SSD-10114 | RESPONSE TO DRAFT CONDITIONS

Thank you for referring the draft conditions for our consideration prior to finalisation of the NSW Department of Planning, Industry and Environment's recommendation to the Independent Planning Commission (IPC) regarding SSD-10114 (Central Coast Quarter).

Figure 1 – Cadastral Boundary

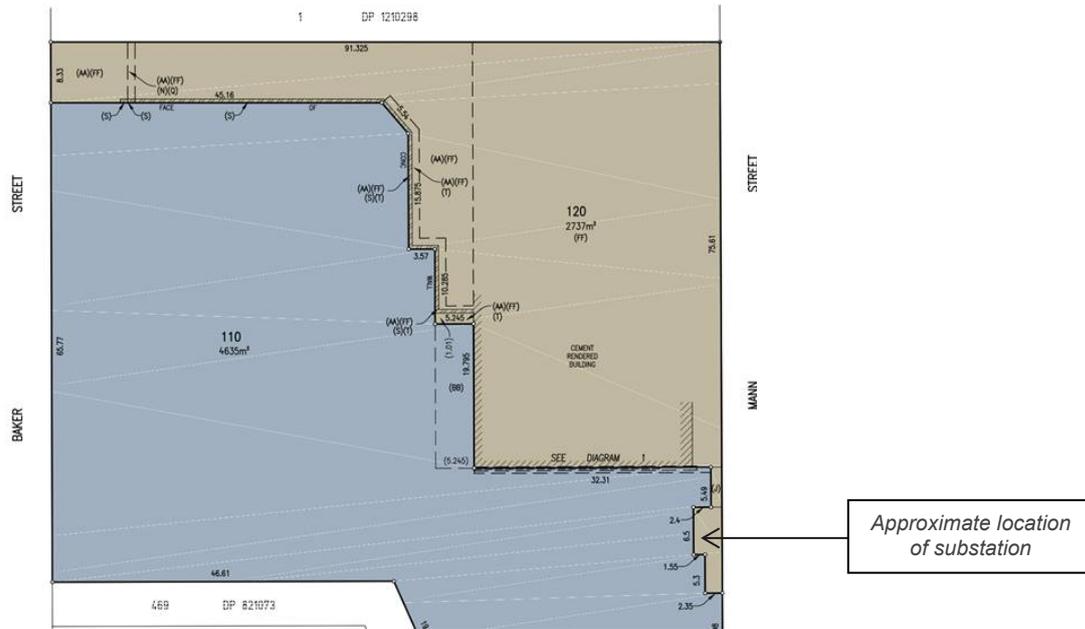
- The substation is located on another Lot, which is not subject of this SSDA. The neighbouring lot has been shrink wrapped around the building, driveway and current transformers (see Figure 1 below).

- e) demonstrate the Mann Street entrance to the through site link (northern arm) is no narrower than ~~7m~~ **5m**.*

Figure 2 – Through Site Link Northern Arm

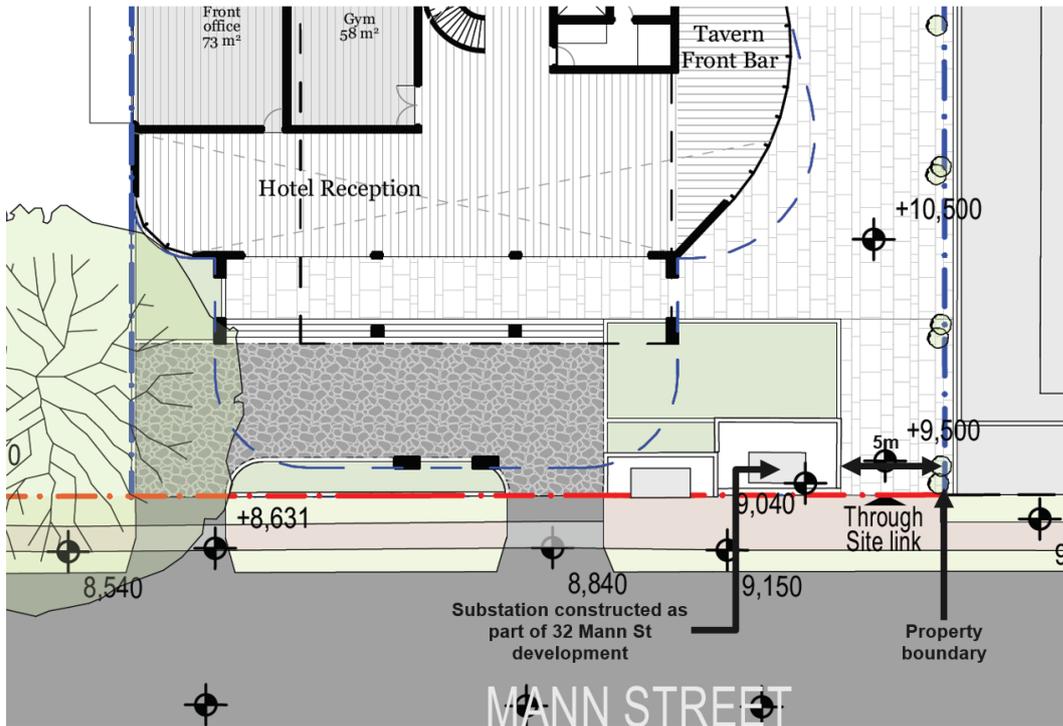
The dimension between the edge of the substation to the property boundary (shown marked below) is 5m. Accordingly, this should be the minimum dimension specified in the conditions of consent, as the substation was recently installed as part of the 32 Mann Street DA (adjoining development) and cannot be readily moved.
